Work Order ID 99869

DART AEROSPACE LTD		Work Order:	99869
Description: Crosstube High Aft (205/212)		Part Number:	D212-664-201
Inspection Dwg: D212-664-241	Rev: D	Page 1 of 1

DRAWING NO. D212-664-241	TITLE CROSSTUBE ASSY (205/212 HI AFT)	REV. D	DART AEROSPACE LTD ENGINEERING ORDER		D.E.O. NO. D212-664-241-D-1	SHEET NO. SHEET 1 OF 2	SCALE NTS
DRAWN	CHECKED	MFG. APPR.	APPROVED	DE APPR.			
DATE 11.04.07	DATE 11.04.11	DATE 11.04.12	DATE 11/04/12	DATE 11.04.12

**D212-664-241/-241B
ASSEMBLY DETAIL**

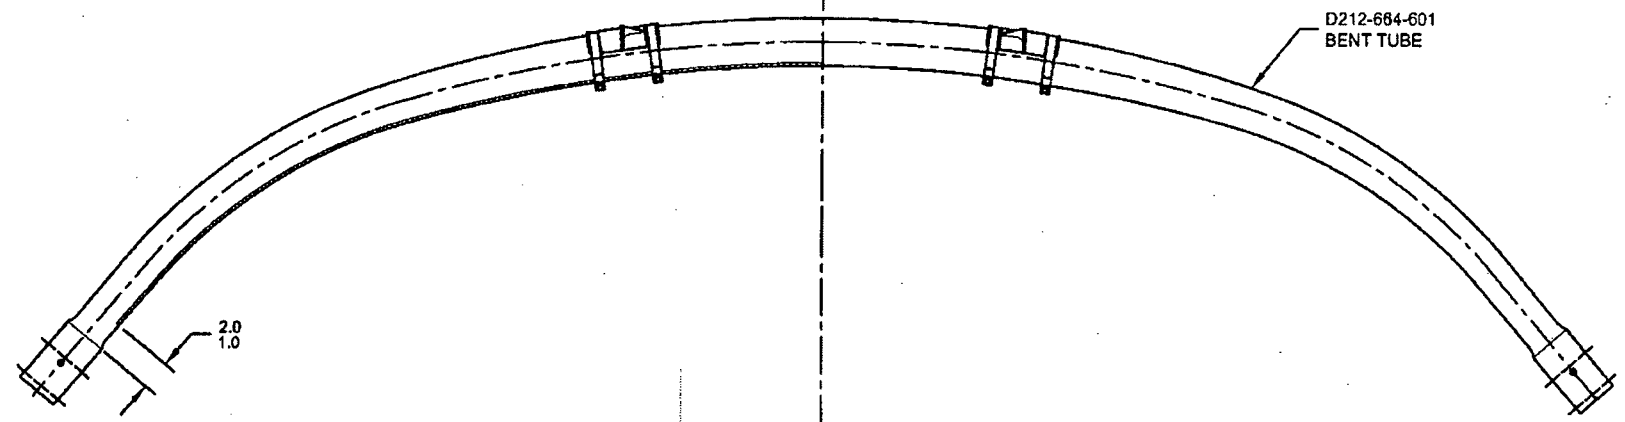
ADD AN INSPECTION WINDOW TO UNDERSIDE OF CROSSTUBE.

NOTES 2 OF SHEET 1 IS AMENDED AS FOLLOWS:

- 2) FINISH: CHEMICAL CONVERSION COAT PER DART QSI 005 4.1
PRIME INSIDE AND OUTSIDE PER DART QSI 005 4.2
MASK UNDERSIDE OF CROSSTUBE AS SHOWN (HATCHED AREA) AND
PAINT OUTSIDE PER DART QSI 005 4.2
REMOVE MASKING AND APPLY CLEAR COAT

MASK AREA PRIOR TO PAINTING,
REMOVE MASKING AFTER PAINT
AND APPLY CLEAR COAT

FIGURE 1: SUPPORT INSTALLATION

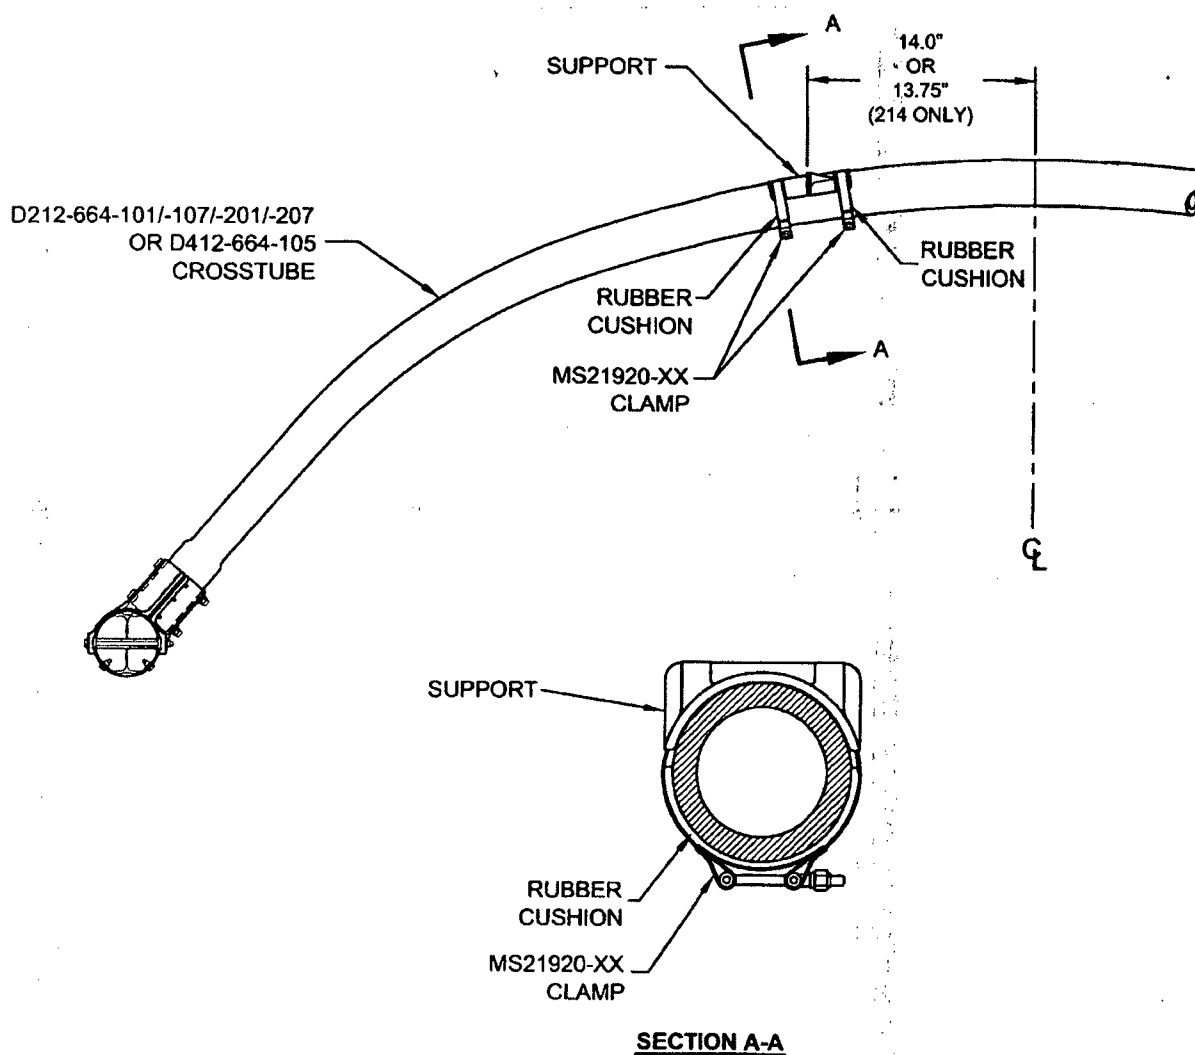
For the crosstubes listed above, section 32.4 of ICA-D212-664 is amended as follows. Use Figure 1 of this service instruction and Figures 32-2 to 32-9 of ICA-D212-664 for further reference. For crosstubes of an earlier change number, it is recommended that if the supports are removed, the supports should be reinstalled using the procedure listed below.

- 32.4.1 Locate the area on the crosstube for installation of support (see Figure 1 of this service instruction). For D212-664-101/-107/-201/-207 and D412-664-105 crosstubes, the outward face of the support tabs should be 14.0" (355mm) from the crosstube center for 204/205/210/412/UH-1 aircraft. For installation on 214B/B-1 aircraft, the outward face of the support tabs should be 13.75" (349mm). Ensure paint finish of crosstube is intact; touch up as required per Chapter 5 (5.3.9) of ICA-D212-664.

- 32.4.2 If present, remove any paint/primer on bottom of supports. Abrade mating surfaces of support and crosstube with 400-grit sandpaper. Saturate a clean cloth with MEK or 4105S Wash'n'Wipe Degreaser or equivalent and wipe until there is no residue.

- 32.4.5 Apply a 0.04" to 0.07" thick layer of Proseal 890 Class B or AMS-S-8802 Class B sealant underneath applicable support and install support as shown in Figure 1 of this service instruction.

- 32.4.6 Install the clamps opposite to crosstube support as shown in section A-A of Figure 1. Install rubber cushions underneath each clamp around the bottom circumference of the crosstube up to the crosstube centerline. Torque clamps 80-100 in-lb (9.0-11.3 Nm). It is acceptable to use smaller or larger sized MS21920-XX clamps than those listed in ICA-D212-664, ensure that after torquing the clamps per this instruction, the nuts are in safety but not bottomed out

CRUSHING OF D212-664-201

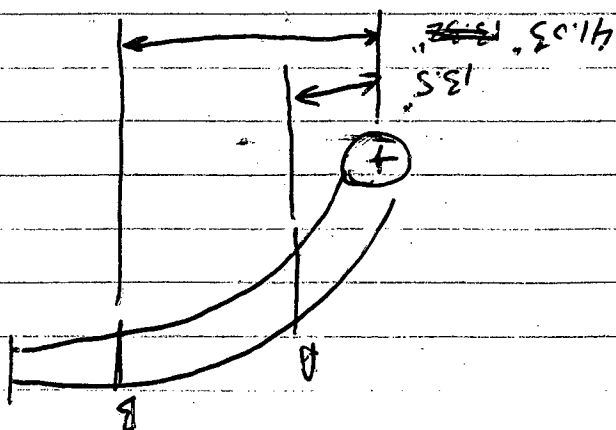
Acceptability of 8% CRUSHING

Point A: $OD = 2.548$ in. $OD = 2.492$ in.
